# CITY OF ALBUQUERQUE

RE: **Monterey Motel**  
**2402 Central SW**  
**Grading Plan Stamp Date: 2/4/20**  
**Drainage Report Stamp Date: 2/4/20**  
**Hydrology File: J12D030**

Based on the submittal received on 2/13/20 the above-referenced Grading Plan and Drainage Report cannot be approved until the following corrections are made:

C-102

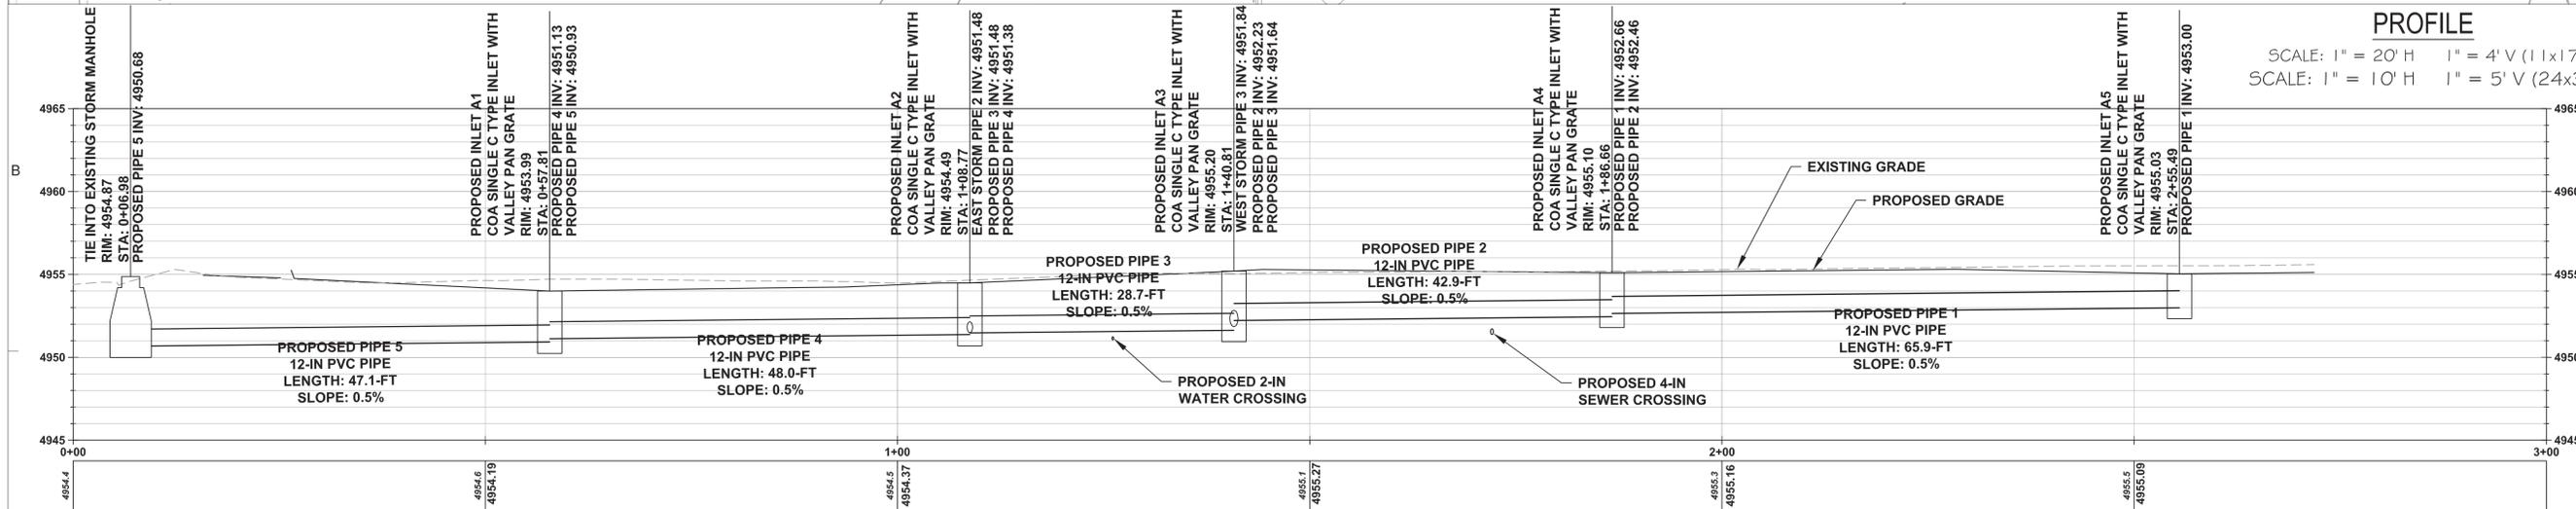
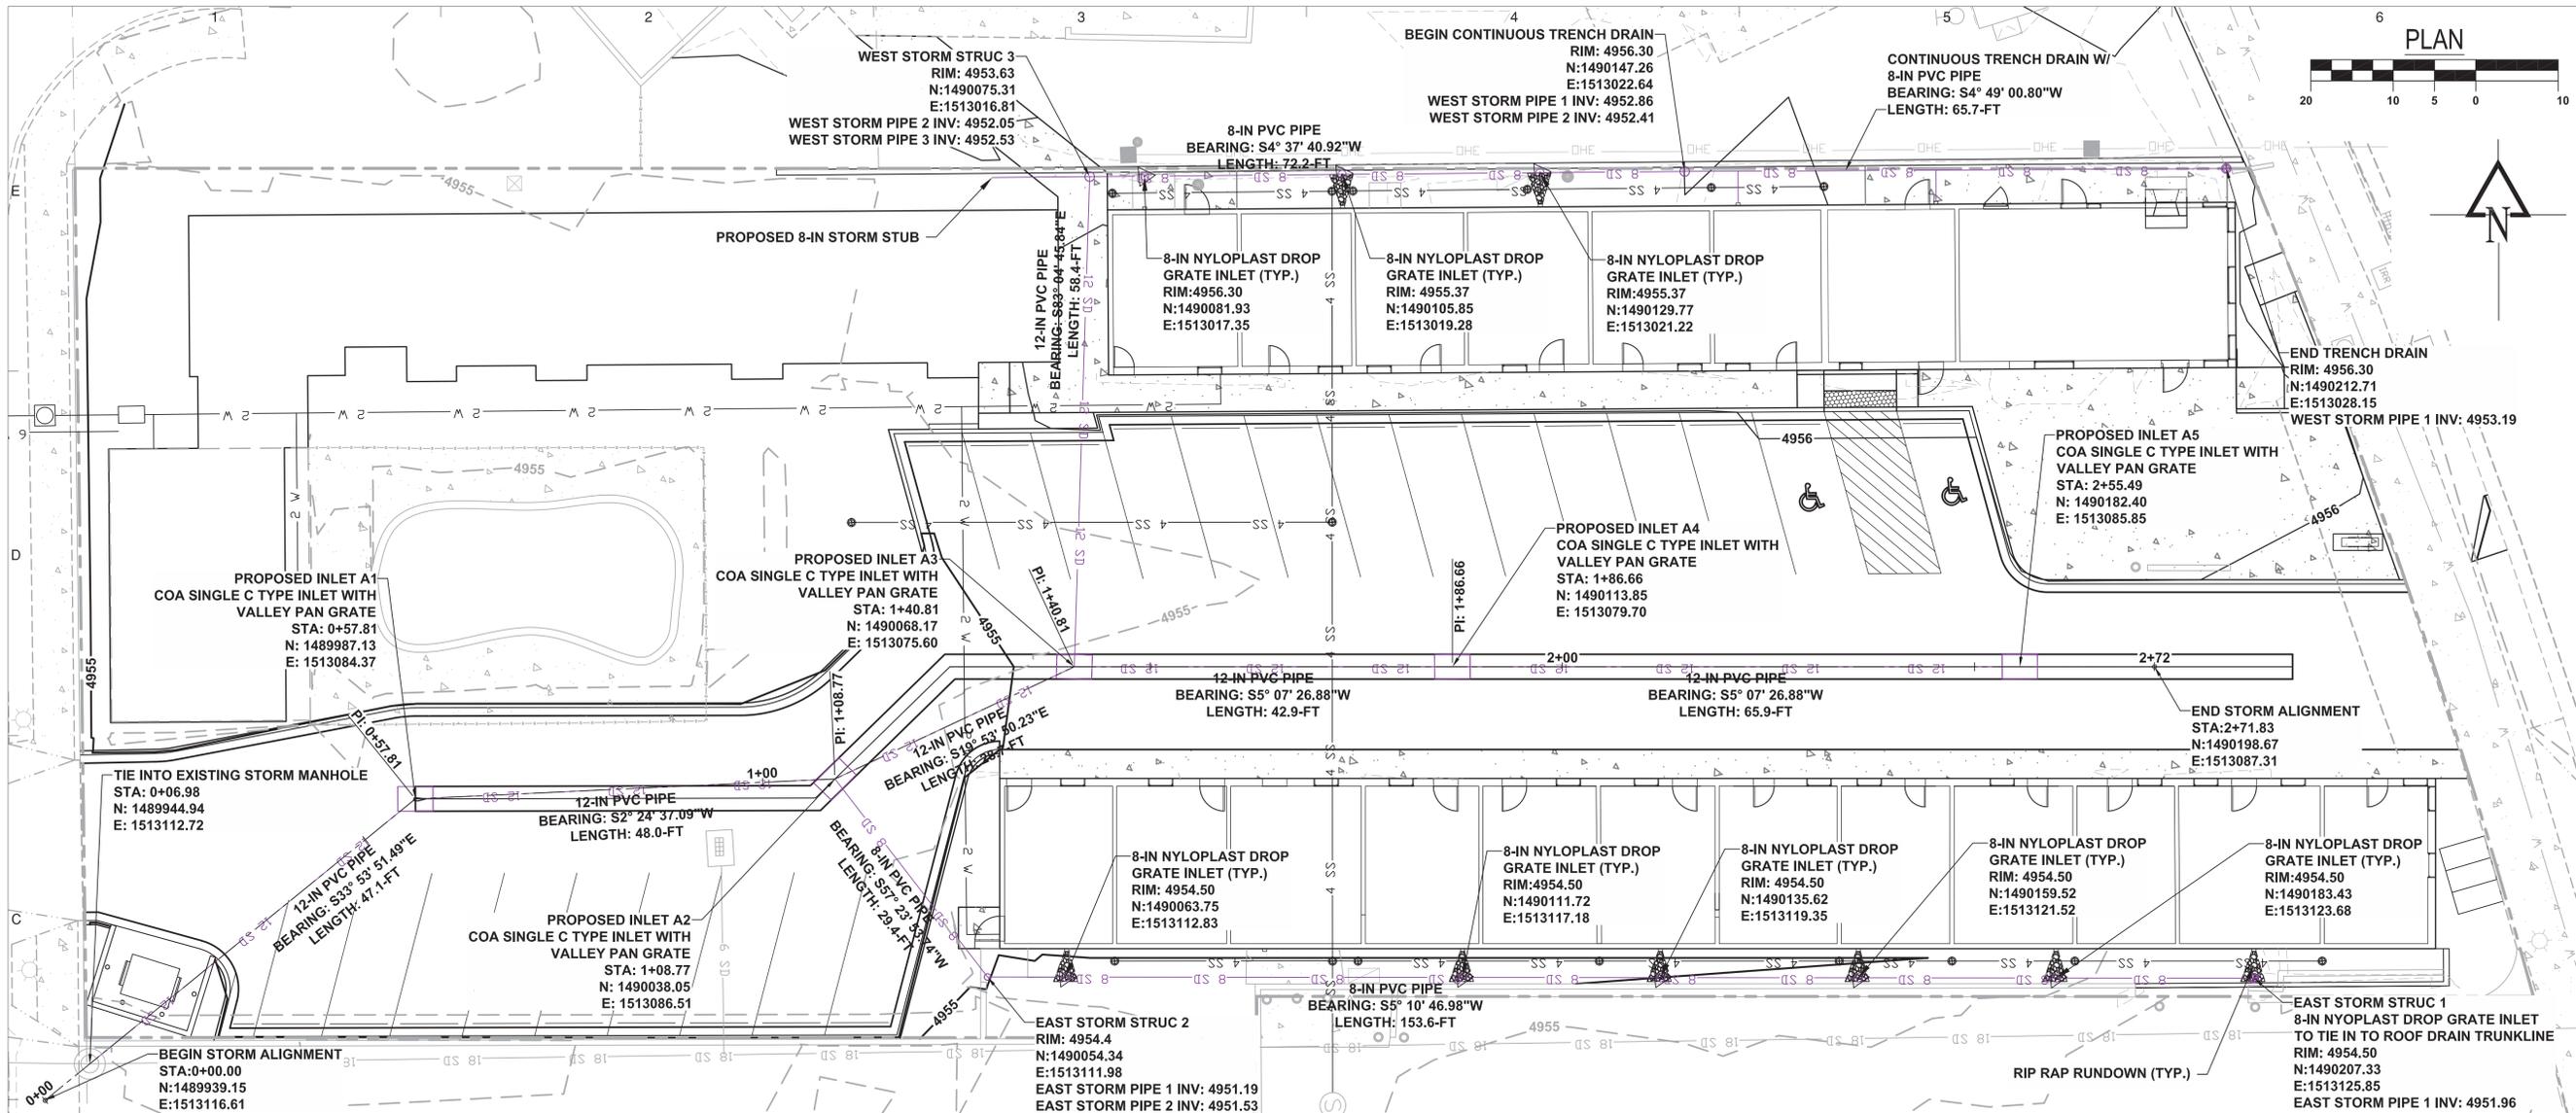
1. Provide written and signed permission from the adjoining property owner (El Vado Place) for the work on their property.
2. The COA inlets in the valley pan should be called out as Type-D, not C.

4. A waterblock, 0.87' high, per COA Paving Detail No. 2426, is required at the driveway entrances.
5. Include project benchmark and datum; all existing survey, proposed grades, and benchmarks must be provided in NAVD 88.

6. Please provide the FIRM Map and floodplain note with effective date.
7. Please provide the legal description of the property on the Grading Plan.
8. Since the site is extremely flat, please provide spot elevations in enough density to verify the drainage areas and outfalls that you have indicated (top of curb, flow line, top of grate, bottom of wall, etc...).
